ASSESSMENT REPORT

Section 96(2) Modification

Oakdale Central Warehouse and Distribution Centres (Lots 1C, 2B and 3) – Modification to Warehouse 2B (SSD 6078 MOD 2)

Figure 4: Proposed Warehouse on Lot 2B

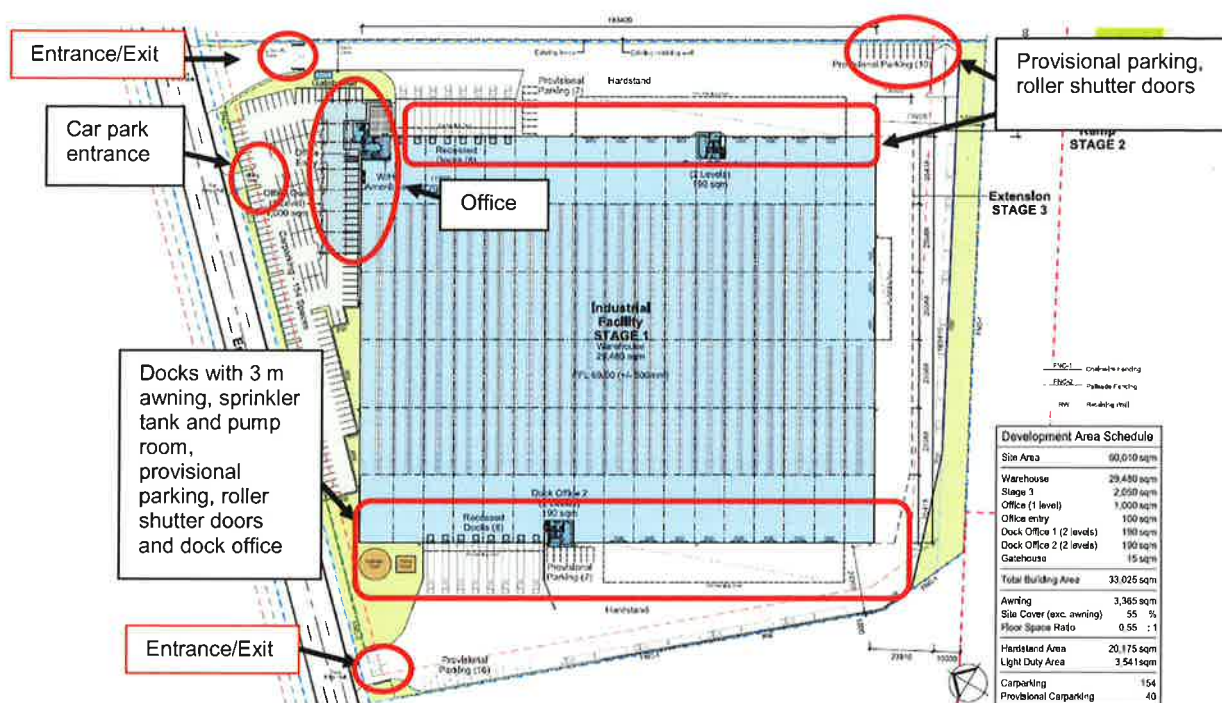
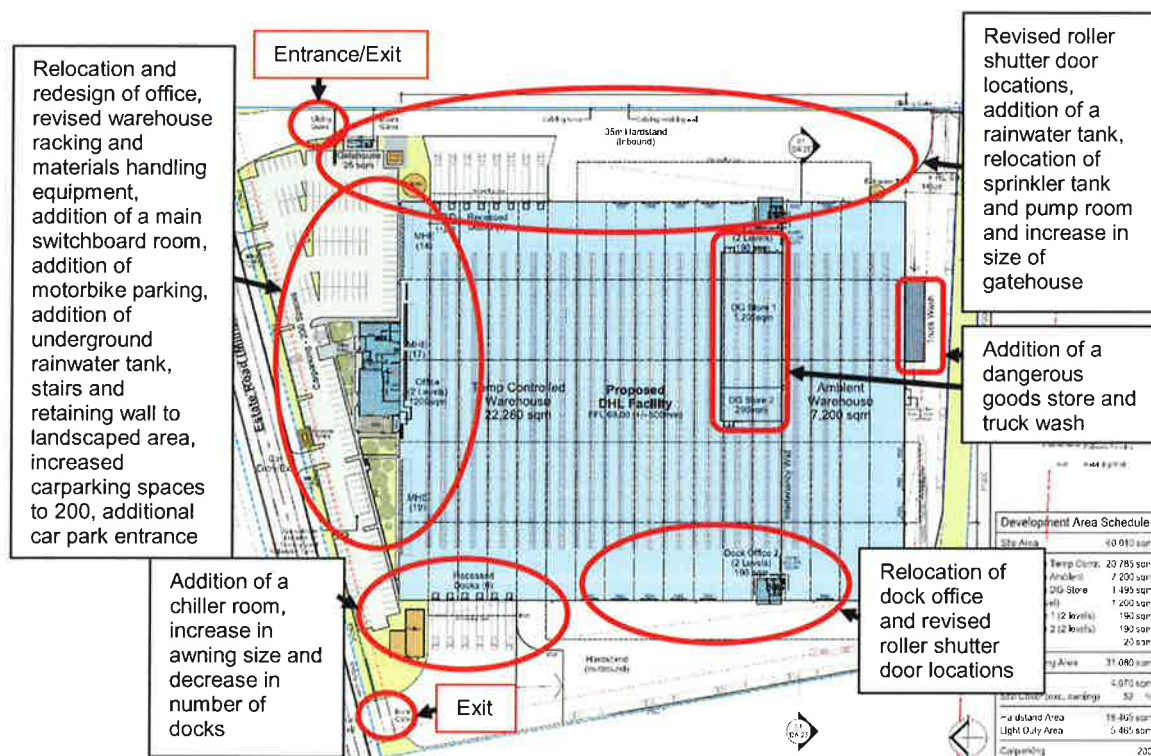
The Applicant is seeking consent to construct and operate two dangerous goods stores with a combined area of 1,495 m² on Lot 2B (see **Figure 4** above). The facility would store a range of Dangerous Goods (DGs), including hair care and skin care products and farm animal treatments. The quantities and classes of dangerous goods proposed to be stored are set out in **Table 3** overleaf.

As the quantities of dangerous goods proposed to be stored exceed the criteria in *State Environmental Planning Policy No. 33 (Hazardous and Offensive Development)*, the DG store is considered potentially hazardous development. As such, the Applicant's assessment included a preliminary hazard analysis (PHA) prepared by RawRisk which assesses hazard related issues resulting from use and handling of the materials identified in **Table 3** above.

The PHA identifies the potential hazardous scenarios on site and the proposed safeguards to mitigate the risks associated with the storage of these goods. The Department's risk specialist reviewed the PHA and concluded that it has been prepared in accordance with *Hazardous Industry Advisory Paper (HIPAP) No. 6 – Hazardous Industry Guidelines (HIPAP No. 6)* and captured the worst-case scenarios.

The PHA identified only one event, a fire involving the entire warehouse, with the potential for off-site impact. However, the risk analysis shows that this type of fire would occur at a frequency well below the relevant risk criteria published in the *Hazardous Industry Advisory Paper (HIPAP) No. 4 Risk Criteria for Land Use Safety Planning*. The individual risk of smoke irritation impact at the site boundary is also well below the criteria for both short-term and long-term exposure.

The Department has reviewed the Applicant's PHA and the agency comments and has concluded that the development will comply with the NSW risk criteria for landuse safety planning and would not increase the overall level of risk in the area, subject to the implementation of all recommendations of the PHA and the implementation of the following conditions requiring:

- the implementation of all recommendations of the PHA;
- the construction of the Dangerous Goods store in accordance with the relevant Australian Standards;
- the preparation of a Fire Safety Study to the satisfaction of Fire and Rescue NSW;
- the preparation of a Final Hazard Analysis in accordance with (HIPAP No. 6);
- the preparation and implementation of a comprehensive Emergency Plan and detailed emergency procedures;
